Access Compliance Report

Public Rights-of-Way

Intersection ID: 24473	Main Street: CAMERON_WOOD_DR	Cross Street: DEER SPRING_LN	Location:	N
ADA ID: 4193F36BBE62	Ramp Type: PerpDiag	Initial Pass/Fail: Fail	Overall Compliance: No	Severity Score: 46.25
Codes/Mitigation Info/Possible Solution		Field Measurements/Component Compliance

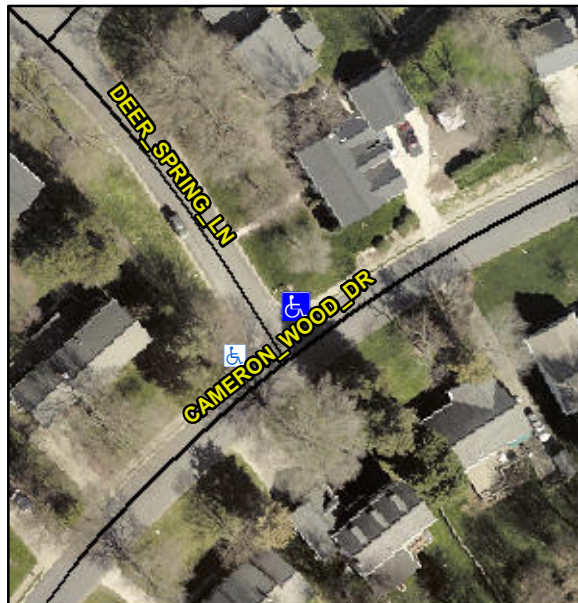
Not Found, R304.5.1, R304.2.2, R304.5.3

Compliance	Description	Data	Compliance	Description	Data
N/A	Ramp Length (in)	63.0	No	Ramp Slope (%)	8.6
No	Ramp Width (in)	39.0	No	Ramp XSlope (%)	14.7
N/A	Flare Type LT	N/A	N/A	Flare Type RT	N/A
N/A	Flare Slope LT (%)	N/A	N/A	Flare Slope RT (%)	N/A
N/A	Flare Traversable LT?	N/A	N/A	Flare Traversable RT?	N/A
N/A	Landing Length (in)	N/A	N/A	DWS Provided?	N/A
N/A	Landing Width (in)	N/A	N/A	DWS Contrast?	N/A
N/A	Landing Slope (%)	N/A	N/A	DWS Length (in)	N/A
N/A	Landing X Slope (%)	N/A	N/A	DWS Full Width?	N/A
N/A	Landing Curb? (Y/N)	N/A	N/A	DWS Offset (in)	N/A
N/A	Shared Landing?	N/A			
N/A	Gutter Ponding?	N/A	N/A	Gutter Slope (%)	N/A
N/A	Gutter Lip Ht (in)	N/A	N/A	Gutter X Slope (%)	N/A
N/A	Painted X Walk1?	No	N/A	Painted X Walk2?	No
	X Walk 1 Direction	To SW		X Walk 2 Direction	To S
N/A	X Walk 1 Width (in)	N/A	N/A	X Walk 2 Width (in)	N/A
	X Walk 1 Slope (%)	9.7		X Walk 2 Slope (%)	1.0
	X Walk 1 X Slope (%)	3.5		X Walk 2 X Slope (%)	12.4

N/A	Ramp inside XWalk1?	N/A	N/A	Ramp inside XWalk2?	N/A
	Road Slope (%)	14.0	N/A	Clear Space?	N/A
	Road X Slope (%)	8.3	N/A	Clear Space to XWalk (in)	N/A
N/A	Any Obstructions?	N/A	N/A	Storm Grate/Utility Hazard?	N/A
	Obstruction Type			Storm Grate/Utility Type	
		N/A			N/A
			Yes	Surface Condition? (G/P)	Good

Remove & Replace Curb Ramp With Two New Directional Ramps or Equivalent.
